Access Compliance Report

Public Rights-of-Way

(Curb Ramps)

Intersection ID: 11974	Main Street: N_BREVARD_ST	Cross Street: E_11TH_ST	Location: W
ADA ID: 551A45EABB3B	Ramp Type: PerpDiag	Initial Pass/Fail: Pass	Overall Compliance: No
Severity Score: 0.25			
Codes/Mitigation Info/Possible Solution		Field Measurements/Component Compliance

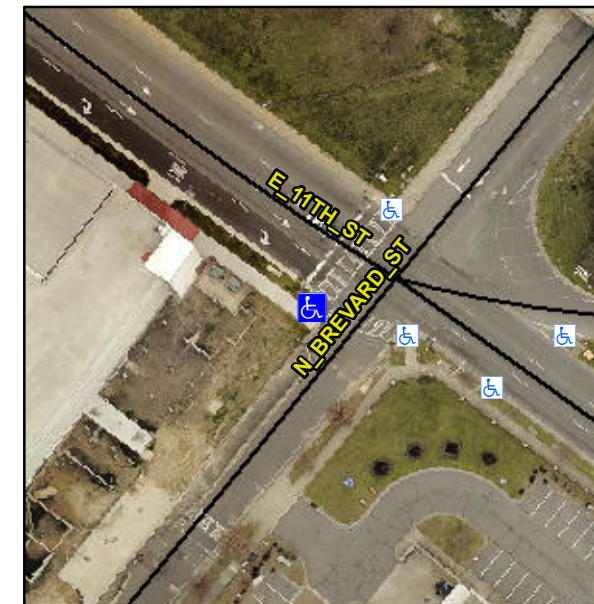
Not Found, R304.5.3, R305.2

Compliance	Description	Data	Compliance	Description	Data
N/A	Ramp Length (in)	86.0	Yes	Ramp Slope (%)	6.5
Yes	Ramp Width (in)	59.0	No	Ramp XSlope (%)	2.2
N/A	Flare Type LT	Sloped	N/A	Flare Type RT	N/A
N/A	Flare Slope LT (%)	6.5	N/A	Flare Slope RT (%)	3.1
N/A	Flare Traversable LT?	Yes	N/A	Flare Traversable RT?	No
Yes	Landing Length (in)	60.0	Yes	DWS Provided?	Yes
Yes	Landing Width (in)	60.0	Yes	DWS Contrast?	Yes
Yes	Landing Slope (%)	0.2	Yes	DWS Length (in)	24.0
Yes	Landing X Slope (%)	2.0	Yes	DWS Full Width?	Yes
N/A	Landing Curb? (Y/N)	No	No	DWS Offset (in)	3.5
N/A	Shared Landing?	No			
Yes	Gutter Ponding?	No	Yes	Gutter Slope (%)	1.0
Yes	Gutter Lip Ht (in)	0.0	Yes	Gutter X Slope (%)	1.8
N/A	Painted X Walk1?	Yes	N/A	Painted X Walk2?	Yes
	X Walk 1 Direction	To SE		X Walk 2 Direction	To NE
N/A	X Walk 1 Width (in)	108.0	N/A	X Walk 2 Width (in)	111.0
	X Walk 1 Slope (%)	3.9		X Walk 2 Slope (%)	0.9
	X Walk 1 X Slope (%)	0.6		X Walk 2 X Slope (%)	1.5

Yes	Ramp inside XWalk1?	Yes	Yes	Ramp inside XWalk2?	Yes
	Road Slope (%)	0.4	N/A	Clear Space?	Yes
	Road X Slope (%)	1.4	Yes	Clear Space to XWalk (in)	72.0
Yes	Any Obstructions?	No	Yes	Storm Grate/Utility Hazard?	No
	Obstruction Type			Storm Grate/Utility Type	
		N/A			N/A
			Yes	Surface Condition? (G/P)	Good

Remove & Replace Curb Ramp With Two New Directional Ramps or Equivalent.
